Service Bulletin

Bulletin No. 2011-03R1
OEM No. 2011-02R1

Official Recall Notification U.S. Federal Boat Safety Act – Verado L6 Shift Bell Crank Replacement

46272

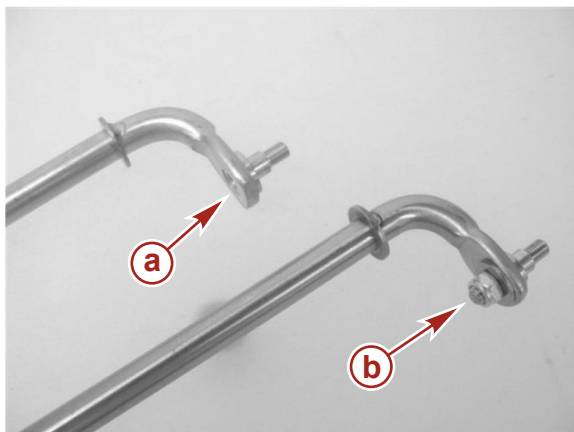
The shift bell crank is painted EDP black and the unpainted upper shift shaft has had its swedged in stud replaced with a double ended stud, washer, and locknut.

IMPORTANT: A number of outboards may have had the shift bell crank replaced without the upper shift shaft being replaced or reworked. These units will require replacement of the swedged in stud with the double ended stud, washer, and locknut.

- a** - Swedged in stud - requires replacement
- b** - Double ended stud, washer, and locknut - has been reworked

Qty.	Description	Part Number
1	Shift shaft stud	91-8M0048988
1	Flat washer	12-35462
1	Locknut M6	11-8M0045046
